F/CMVSS Noncompliance Recall

N192218960 Incorrect Rear Quarter Glass

Release Date: July 2019

Revision Description: This bulletin has been updated in the part information section. Please discard all copies of N192218960.

5339678

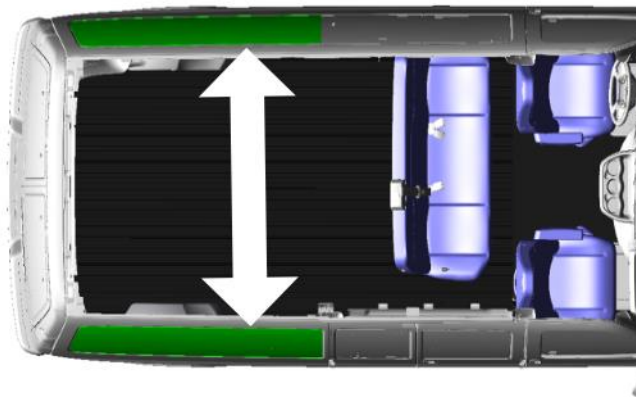
NOTE: Locate the model number on the information label positioned in the lower rear area of the driver door (example shown above only - see the correct model numbers for short and long wheel base model numbers below).

5340243

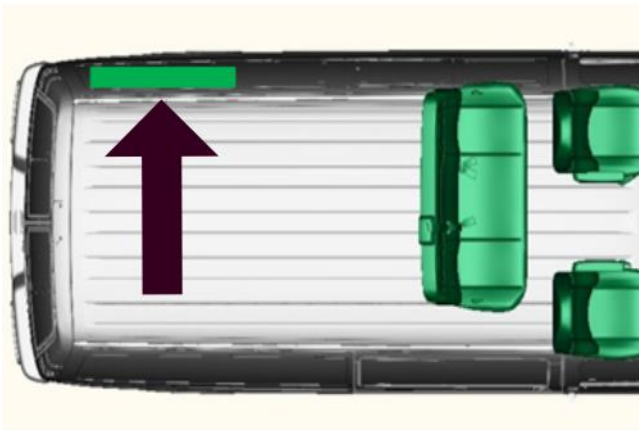
Long Wheelbase Vehicles (Model numbers G23705/G33705)

- Replace the **left** rear quarter glass window. Refer to *Adhesive Installation of Bodyside Stationary Windows* in SI.
